Dixie-Narco®

Service Bulletin # 268

MODELS: 1 1/4" DNCB - Narrow Columns Only

SUBJECT: Adjustable Cam for Narrow Column Vend Motors only.

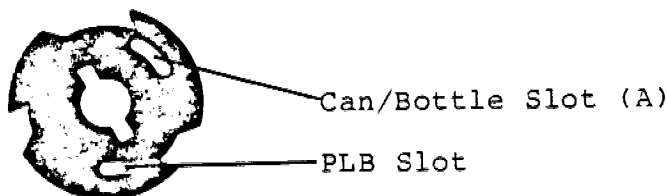
WHEN TO USE THE

ADJUSTMENT SLOT: Use the adjustment slot PLB when the vend rotor does not travel far enough to vend the front bottle.

Cam

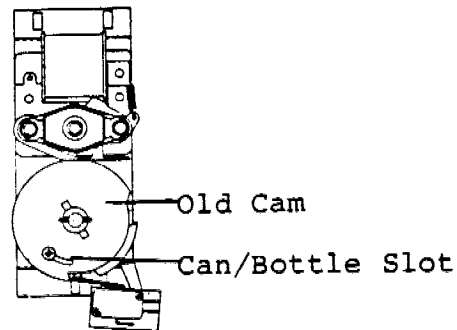
REASON: To provide a Cam which has an adjustment slot for the 10 oz. NR PLB (Bottle).

1. As venders are produced, they will continue to be shipped set for 12 oz. cans. That is Can/Bottle slot, A, Fig. 1 will be used. The PLB Slot is an added feature.
2. To adjust or install a new cam - Unplug the vender.
3. When vending the 10 oz. NR PLB (bottle), narrow column it may be necessary to remove the screw from slot A, rotate the cam and install the screw in Slot PLB. By doing this, the vend rotor will travel farther. If a new cam is needed, replace the old cam with the new cam and use the outlined procedure to install.

ORDER AS: Part #801,804,290.01 - Cam
